Waimea Water Augmentation
Committee

Lee Valley Dam
Detailed Design Report Stage 3

October 2012 (revised July 2014)

T&T Ref: 27425.100 Resource Consent Issue

Figure above shows the Stage 1 design commented upon. Differential settlements at the perimetric joint were a potential issue.

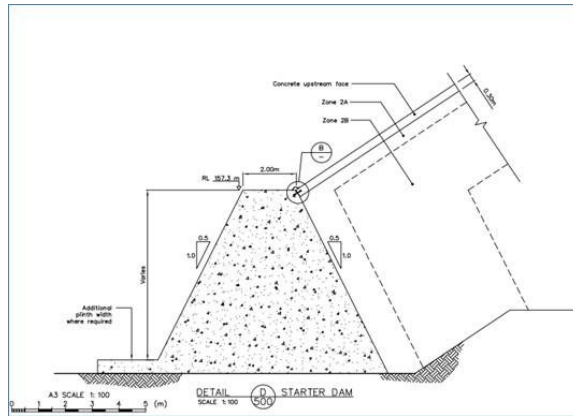
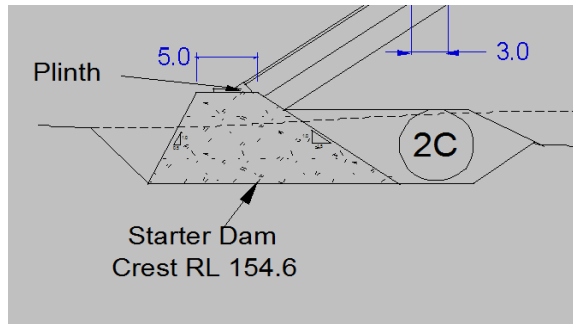
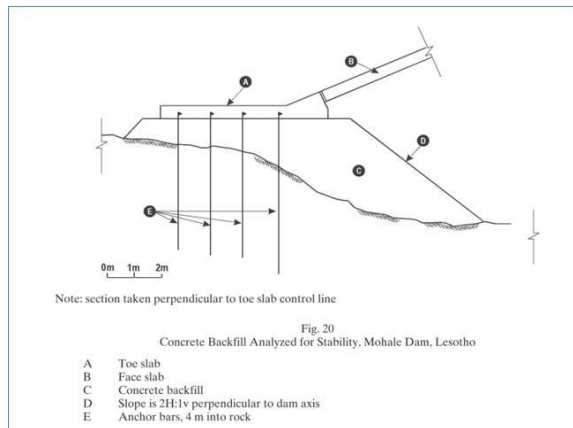
The perimetric joint detail at the starter dam (dwg 250) indicates that the supporting internal formed face slope is other than perpendicular to the membrane plane immediately below the joint. Supporting detail needs to be provided to show the performance of the joint under severe seismic loading will not be compromised by this design.

This detail has been refined.

The design has changed substantially since Stage 1. See figure below.

The Stage 3 design shown below has a downstream slope of 1.5h:1v and is backfilled with relatively stiff alluvial gravels. The combined effect of the stiffer backfill material and flatter starter dam backslope is expected to keep differential movement between the face slab and the starter dam to acceptable levels. In accordance with ICOLD B141 guidelines it avoids a high fill depth adjacent to the perimetric joint and provides a gradual increase in fill thickness with distance from the joint.

It is also similar to configurations adopted for the Mohale Dam plinth – See figure below.
